PRE-APPLICATION CONFERENCE

La Center School District Middle School (File # 2018-020-PAC)

Meeting conducted on Tuesday, August 23, 2018 – 9:30 AM

Map of Riparian Areas in Project Area

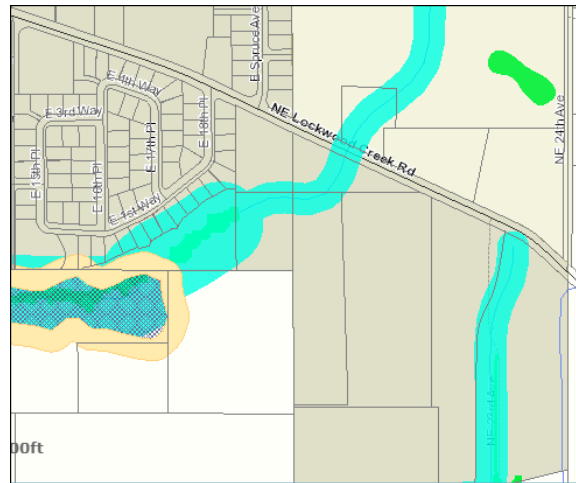
The applicant states, and staff agrees, that there are two regulated critical areas on or abutting the site: wetlands and fish and wildlife habitat conservation areas. The site includes CARA 2 coverage but the school use will not trigger additional CARA 2 review. The city also regulates impacts to Oregon white oak trees if present on site.

A Type NS stream is shown on the northwest corner of the site. The anticipated buffer is 75 feet. Water types are defined and mapped based on WAC [222-16-030](#) or [222-16-031](#), whichever is in effect on the date of application. While the WAC definitions control, the Critical Area code allows an applicant the opportunity to prove that state or county designations are inaccurate by applying Best Available Science. See, LCMC 18.300.090(2)(e). Only buffer reductions are allowed on Type Np and Np streams. See LCMC 18.300.090(2)(f).

A Species and Habitat Assessment Report is required consistent with LCMC 18.300.090(2)(d). The buffer standards in LCMC 18.300.090(2)(g) and (h) apply. Based on the site plan presented at the conference it appears that impacts to the stream and buffer are not proposed. Enhancements to the riparian buffers could make an excellent environmental learning project.
